UNITED STATES PATENT AND TRADEMARK OFFICE

| APPLICATION NO. | FILING DATE | FIRST NAMED INVENTOR | ATTORNEY DOCKET NO. | CONFIRMATION NO. |
|-----------------|-------------|----------------------|---------------------|------------------|
| 09/832,892 | 04/12/2001 | Takehisa Yamaguchi | 205975US2 | 1675 |

Office Action Summary

第 1 図

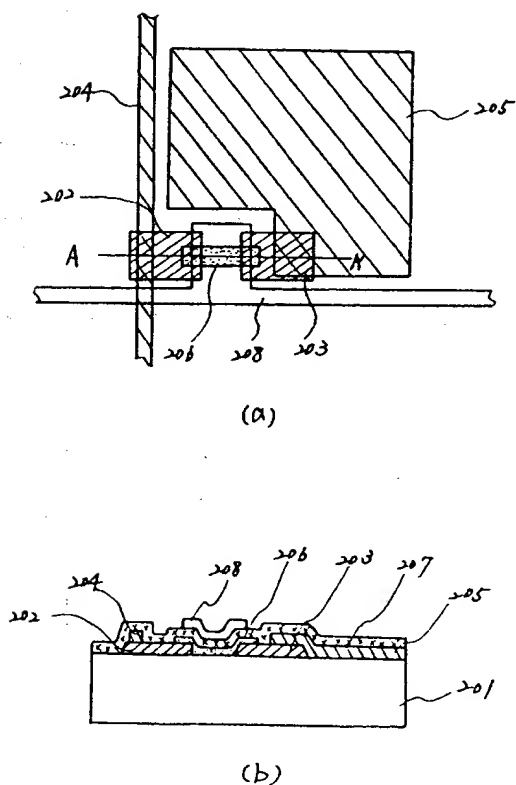
Takashi teaches (Fig. 1) a liquid crystal display comprising:

- a gate electrode line 106 including a gate electrode formed on an insulating substrate;
- a source electrode line 108 including a source electrode 103 intersected with said gate electrode line 106 via an insulating film (gate insulating film 105);
- a thin film transistor including said gate electrode, said source electrode, and two drain electrodes located in a vicinity of a portion in which said gate electrode line is intersected with said source electrode line;
- two drain electrode lines 102, each including a portion acting as one of the two drain electrodes, said two drain electrode lines being connected with a pixel electrode 107;

- said two drain electrodes are located on opposite sides of said source electrode with each of said two drain electrodes having a near side opposed to said source electrode that is superposed with said gate electrode and a far side opposed to near side that is not superposed with said gate electrode.
- an area of a region where said gate electrode line 106 is superposed with the near side of one of said two drain electrodes is substantially identical to an area

of a region where said gate electrode is superposed with the other one of said two drain electrodes as shown in Fig. 1b according to claim 2.

Takaski discloses drain electrodes having the near sides thereof facing a source electrode superimposed over a gate electrode with the far sides of each drain electrode opposed to the near side not being superimposed over the gate electrode and being connected to pixel electrode (see attachment).

+ near side opposing to far side
+ near side facing the source electrode 103
